AGENDA ITEM: 653-168

Title: Hot Tap, Items 6 & 7

Purpose: 1. Clarified NDE requirements for hot tap welds.
2. Clarified nozzle test pressure requirements per API 653, Section 9.14.5.3.

Figure 9-6—Hot Tap for Tanks (SEE NOTE 1)

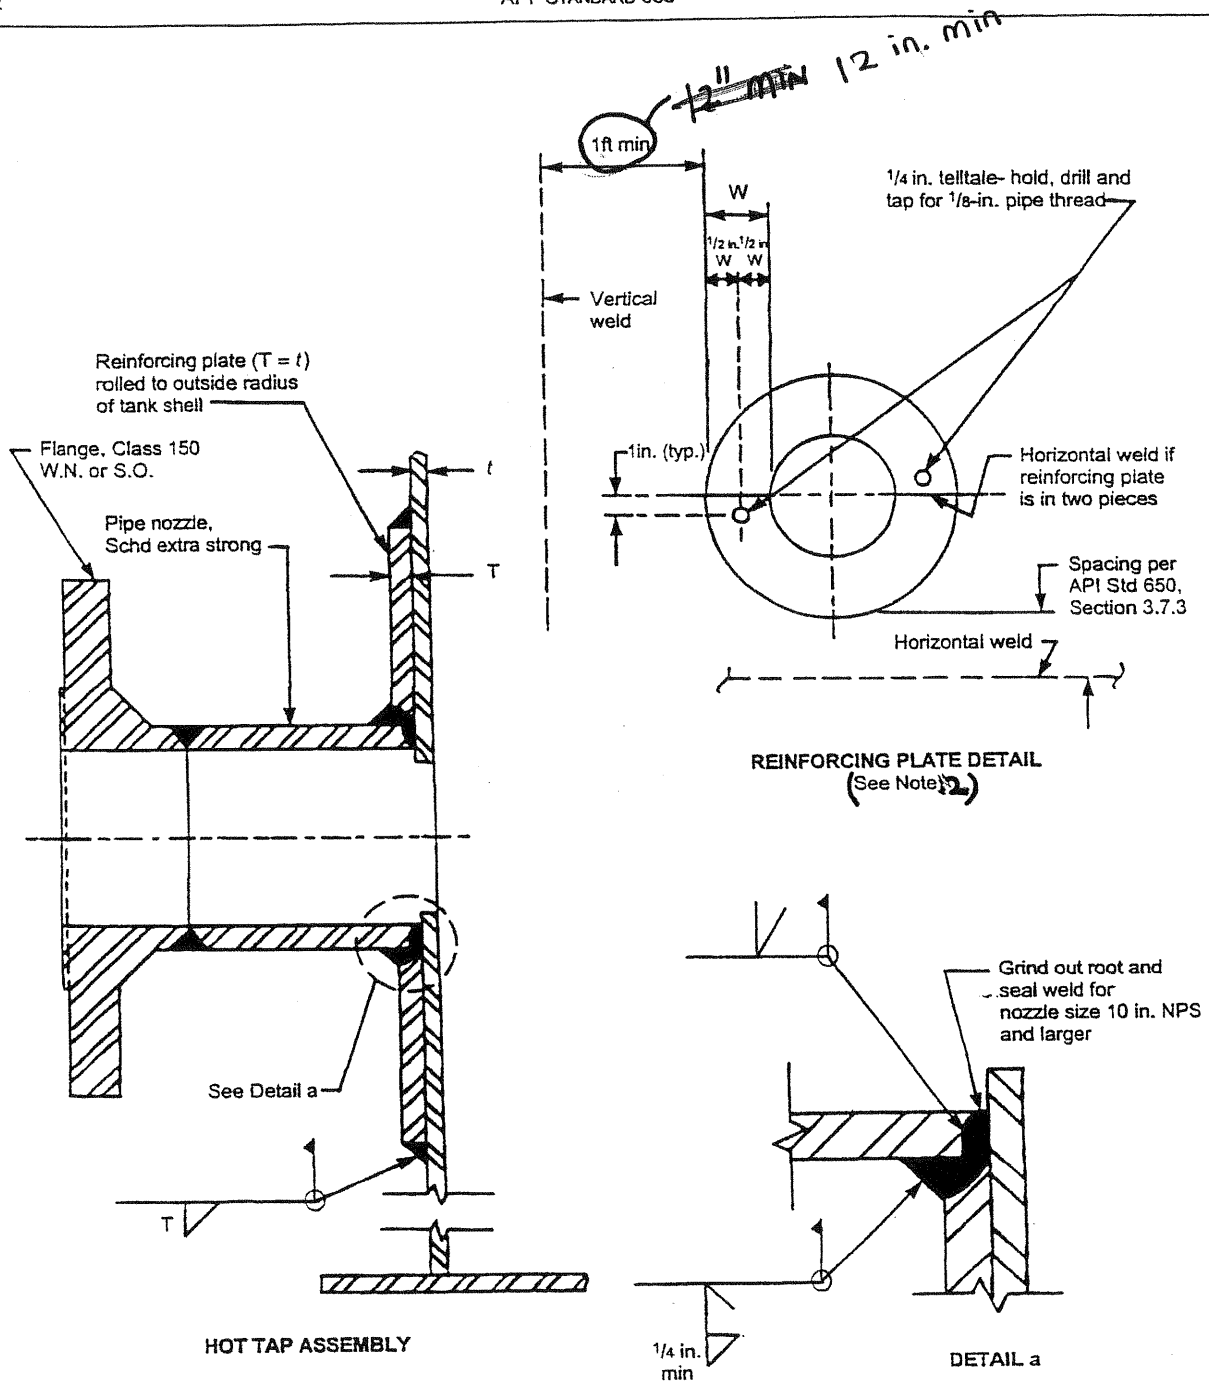
Figure 9-6—Hot Tap for Tanks (**See attachment for changes**)

9.14.5.2 After the pipe is welded, the reinforcing plate shall be installed either in one piece or two pieces ~~with horizontal weld in accordance with Figure 9-6.~~ The reinforcing plate to nozzle shall be installed with a full penetration weld. Care shall be taken to limit the heat input to the welds. ~~The reinforcing plate to reinforcing plate weld, reinforcing plate to shell weld, and reinforcing plate to nozzle neck weld shall be examined by nondestructive examination (see 12.1.2.3) in accordance with 12.1.2.3.~~

1. REFER TO 12-1 FOR NONDESTRUCTIVE EXAMINATION REQUIREMENTS.
